Technical Service Bulletin

| Subject: POOR AIR CONDITIONING PERFORMANCE AND OPERATION | Bulletin No.: 07-005/17 |
| | Last Issued: 05/12/2017 |

2016-2017 CX-9 vehicles with VINs lower than JM3TC*****135223 (produced before Jan. 6, 2017)

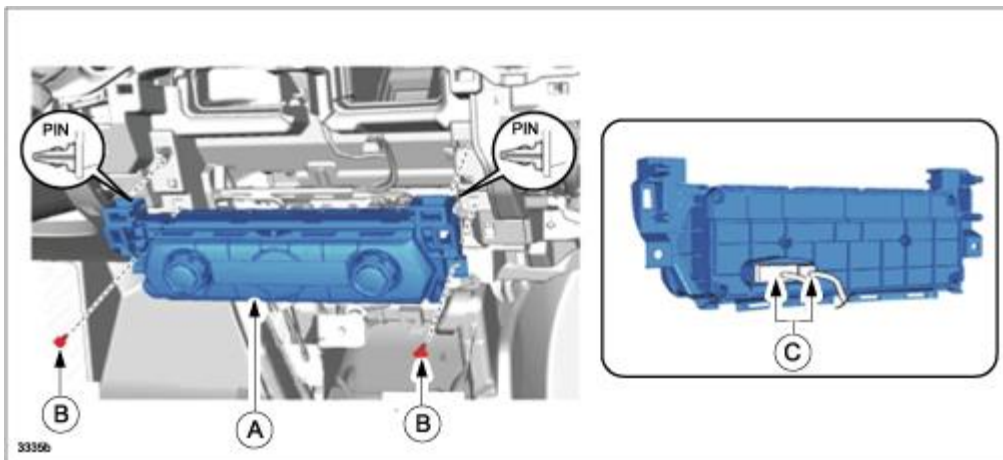
3. Measure the air conditioner output temperature from the passenger's side center ventilator (A) and rear ventilator (B) outlets according to the instructions on MGSS online (REFRIGERANT SYSTEM PERFORMANCE TEST). Record the output temperature values with a dry-bulb thermometer (C) and the ambient temperature when it is measured.

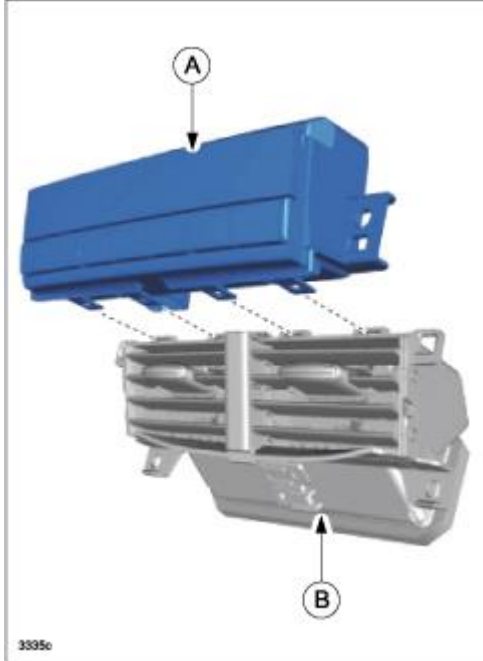
6.Replace the front climate control unit (A) with a modified one according to the instructions on MGSS online (FRONT CLIMATE CONTROL UNIT REMOVAL/INSTALLATION). Screws (B) and connector (C).

7.(FOR TYPE A VEHICLES ONLY) Replace the rear climate control unit (A) with a modified one according to the instructions on MGSS online (REAR CLIMATE CONTROL UNIT REMOVAL/INSTALLATION). Rear ventilator grille (B).
